In the Matter of: Entergy Nuclear Operations, Inc.
(Indian Point Nuclear Generating Units 2 and 3)

NRC000114D
 Resubmitted: April 2, 2012

RAI Set #3 Final Responses – 07/08/10

Subject: EPRI MRP Final Response to: REQUEST FOR ADDITIONAL INFORMATION NUMBER 4, RE: ELECTRIC POWER RESEARCH INSTITUTE TOPICAL REPORT 1016596, 'MATERIALS RELIABILITY PROGRAM: PRESSURIZED WATER REACTOR INTERNALS INSPECTION AND EVALUATION GUIDELINES (MRP-227-REV. 0)' (TAC NO. ME0680), August 30, 2010

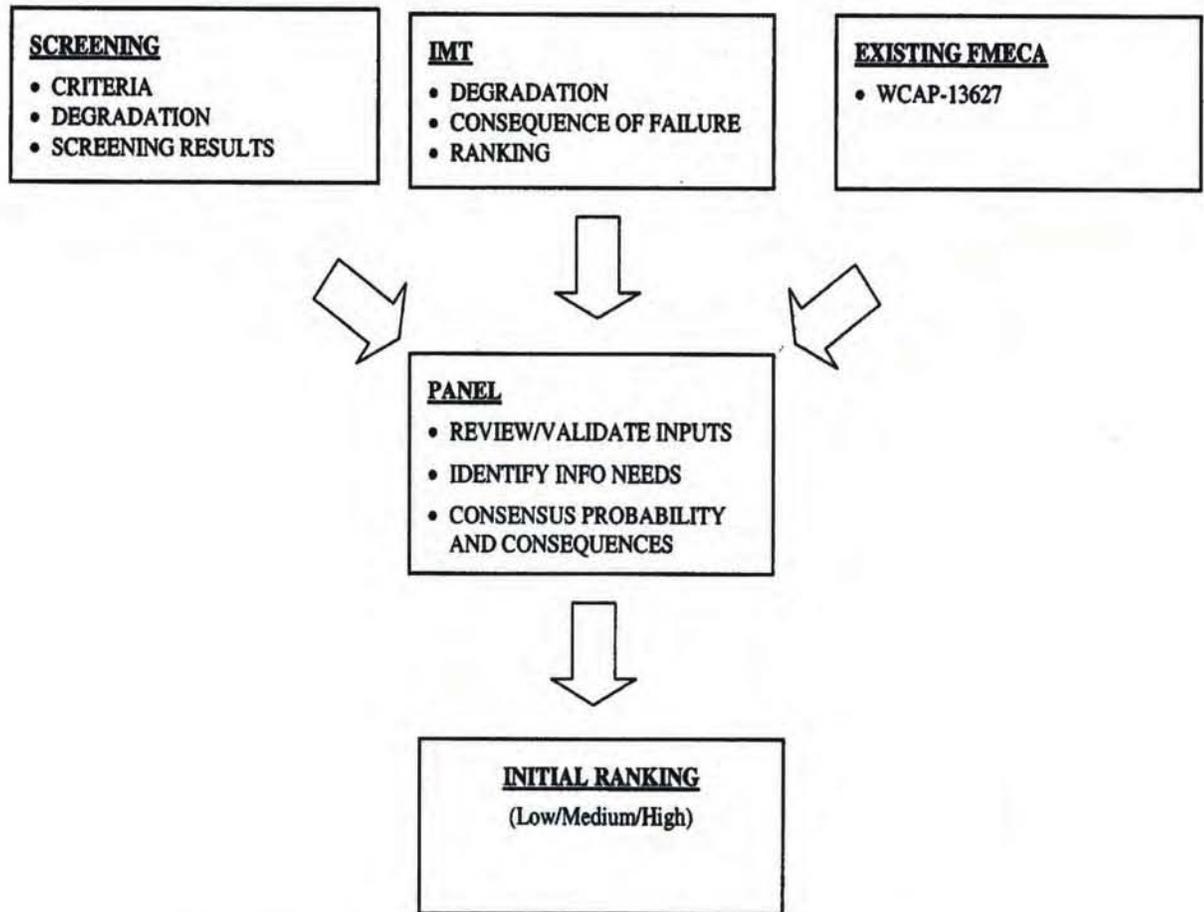
RAI 4-3(a) asks for the list of experts who participated in the FMECA process and their technical areas of expertise. The list of experts for the FMECA documented in MRP-190 and their areas of expertise is shown on the Acknowledgements on Page ix of MRP-190. MRP-191 does not provide the list of experts and their areas of expertise, but the areas of expertise were provided in the presentations given to the staff on June 8, 2010. For completeness, the Combustion Engineering/Westinghouse FMECA areas of expertise are shown below:

- Component Design
- Materials
- Finite Elements/Stress/Dynamics Analysis
- Structural Analysis
- Non-Destructive Evaluation
- Fracture Mechanics
- License Renewal
- Safety/Accident Analysis
- Thermal-Hydraulics
- Neutronics/Radiation Physics

Demand for MRP-227 SER PWRs Entering Period of Extended Operation

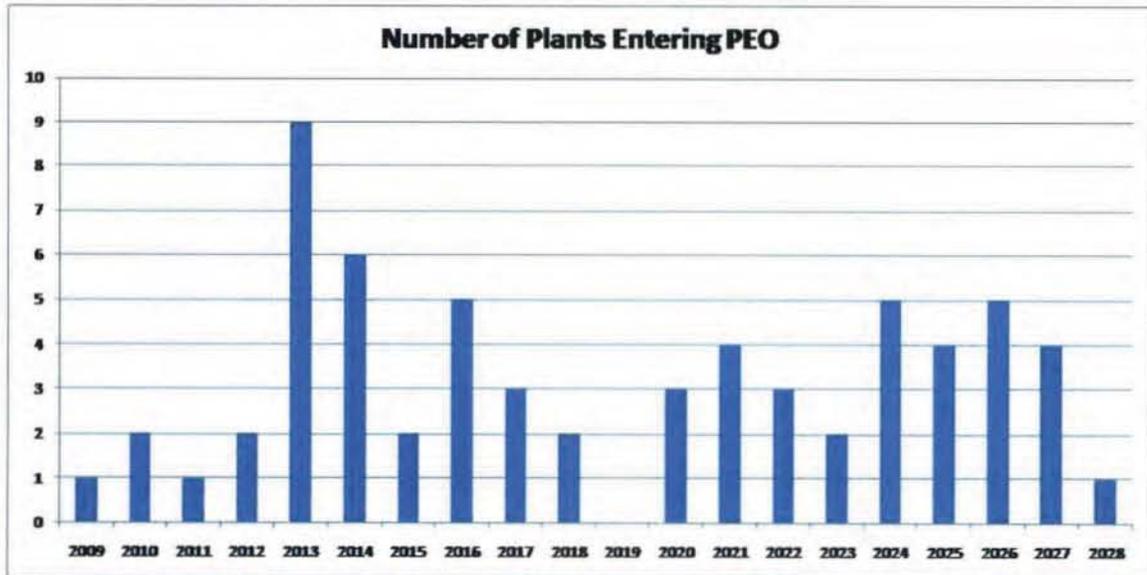
Alternatively, provide information about the plans of licensees to perform the initial primary inspections required by MRP-227. Staff understands that some licensees are planning to inspect all required primary components during the first refueling outage after entering into the license renewal period. Staff therefore seeks to determine if this approach is being adopted by other licensees that have or will shortly enter the license renewal period. Clarify if this approach is either recommended or required within MRP-227.

Response: The response to RAI 2-1 (Set #2) described the results of the component degradations in the functionality analyses as very gradual, with no sudden increases during either the 30 years of simulated high-leakage core loading or the subsequent 30 years of low-leakage core loading. From this work, it was determined that: (1) inspections immediately prior to or immediately following the beginning of the extended period of operation would have similar likelihoods of detecting and characterizing any degradation present in the reactor internals Primary components, and (2) no basis for departure from the standard ten-year inspection intervals to more frequent inspection intervals was warranted. The latter determination was supported by both operating experience and the results of ASME Section XI Examination Category B-N-3 inspections conducted during the first 40 years of operation. In addition, since MRP-227 is a living document, which will be updated to reflect both positive and potentially negative information from inspection results obtained by a series of plants entering the period of extended operation over the next several years, the currently-specified inspection periodicity will be reviewed and altered, as needed, to incorporate that information. As currently anticipated, some five or six plants will be conducting all or portions of the inspections specified in MRP-227 in the next four years. Additionally, as can be seen graphically below, the US PWR fleet will have units entering their period of extended operation over intervals sufficient to ensure examination results are regularly being collected.

Even more to the point, the inspection results could result in the detection and sizing of defects that might require engineering evaluation for disposition. In such cases, the engineering evaluations will provide clearer evidence than is now available on the level of degradation that is acceptable, and subsequent inspections will provide information on the rate of increase in that degradation. This type of information will provide additional grounds for sustaining or modifying the current inspection periodicity. Considering the operating history of PWR internals in the United States, the results of ASME Code prescribed examinations on internals over the first 40 years of operation, and the conservative results from the functionality analyses, the current inspection periodicities are considered consistent with the intent of the 10CFR54 requirements. Further, on the same basis, they are considered adequate to identify potential degradation of the non-pressure boundary components associated with the reactor internals with the potential for either increasing or decreasing that periodicity as warranted by initial examination results.

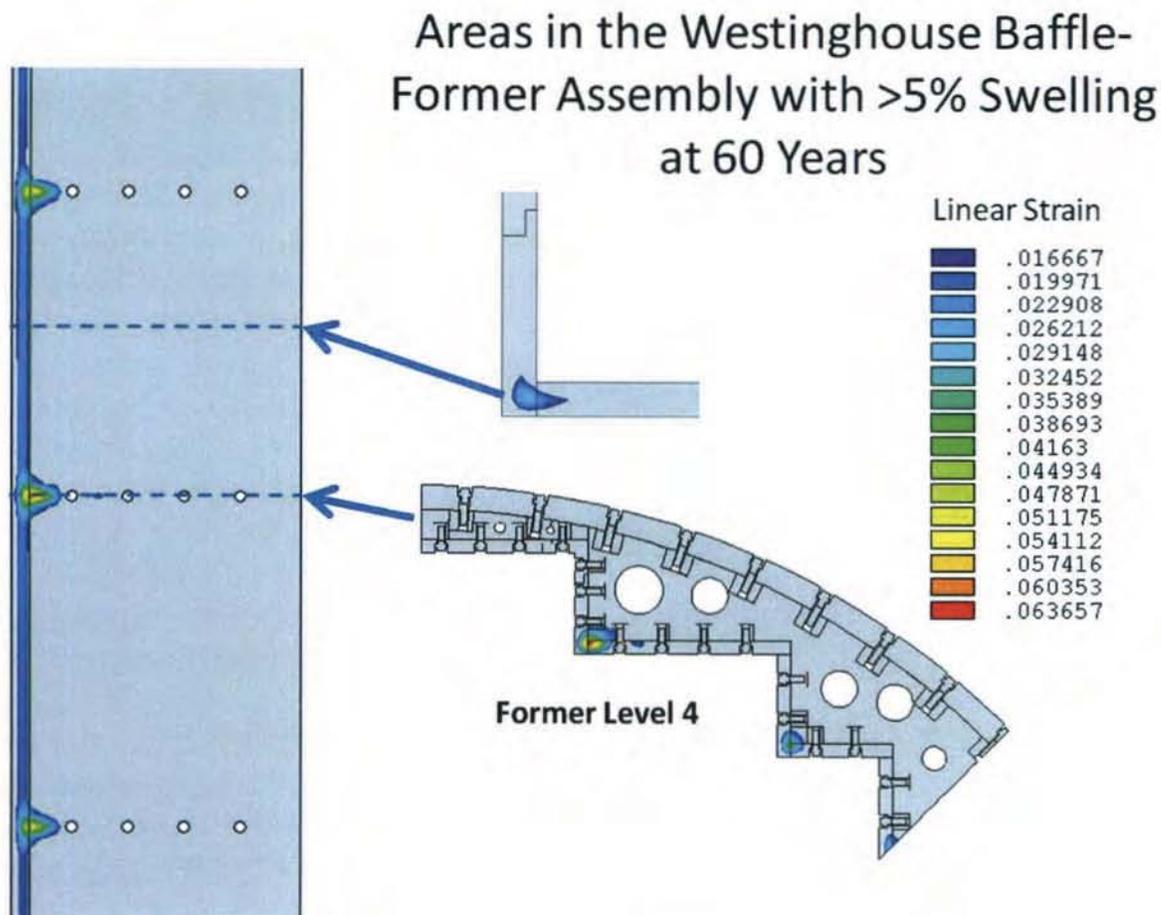
RAI 4-18: As a follow-up to RAI-26 (second set of RAIs), please clarify if components that are predicted to locally exceed 5% swelling by volume are inspected for cracking at those locations. Provide justification why any such components that exceed this criterion are not recommended for inspection.

Response: For the B&W design, there are no locations predicted to locally exceed 5% swelling by volume. For the CE and Westinghouse designs, the MRP-227 I&E Guidelines monitor the distortion caused by the integrated effects of void swelling over the entire volume of a PWR internals assembly. The inspections that implement this requirement are shown in Tables 4-2 and 4-3 of MRP-227 for Combustion Engineering and Westinghouse plants, respectively. The inspections focus on the regions of high swelling and locations where the accumulated effects of swelling over the assembly are most likely to be visible. The particular distortions that led to the recommendations were the result of the functionality analyses reported in MRP-229 and MRP-230.

These functionality analyses showed that the volumes of material for which relatively high “effective irradiation strain growth” was calculated were very small and localized, to regions of combined high fluence, high gamma heating, and limited cooling. (Note: the volumetric swelling is equal to 3x the irradiation growth strain.) In the Westinghouse design, the high swelling regions were limited to high fluence seams where there are joints between the baffle and former plates. Typical Westinghouse high fluence regions are indicated in the accompanying figure. MRP-227 requires VT-3 examinations of the baffle-former assembly and the baffle-edge bolts at these locations. Even though the FEA aging evaluation included these levels of swelling, the analysis did not indicate stresses high enough to initiate IASCC in these components. The high swelling locations are remote from significant structural load paths and cracking at these locations is not expected to have a significant structural impact. Therefore it was determined that the

A similar situation occurs near the mating surfaces of the upper and lower core shroud former plates in the CE design (MRP-227 Figure 4-14). The MRP-227 guidelines require inspections of the joint for observable distortion and the adjacent welds for cracking. Because the welds are considered a structural element, the requirement is for an EVT-1 inspection at the joint.
